MP10_160 Mod 6 White Rock Wind Farm (WRWF) - Further Information

This letter has been prepared by White Rock Wind Farm Pty Ltd (WRWFPL) in response to the Department's request for further information (RFI, email dated 21 November 2018), to address additional comments received from the Office of Environment and Heritage (OEH) and the Roads and Maritime Service (RMS).

1. OEH Request for Further Information (Letter dated 5 November 2018)

2. RMS Request for Further Information (Email dated 8 November 2018)

481.2 Km's: New England Highway onto Ben Lomond Road.
Image 1: (82 and 76 Metre blade)

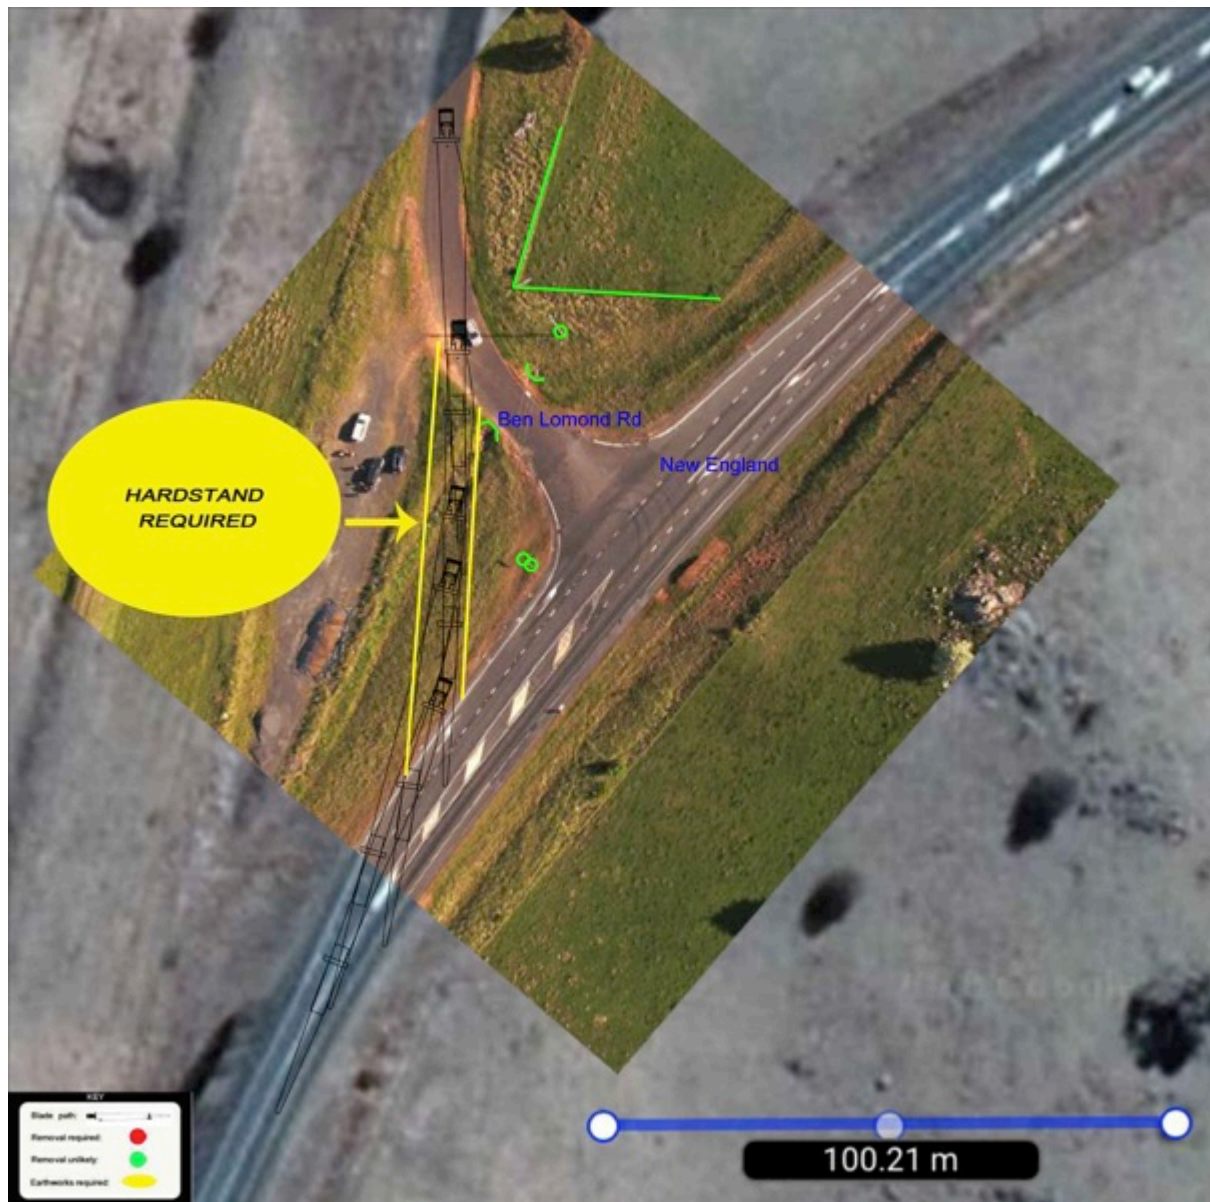
PROCEDURE: Loads to veer to the left through an upgraded hardstand area.

ROAD MODIFICATIONS: Large amounts of work are required.
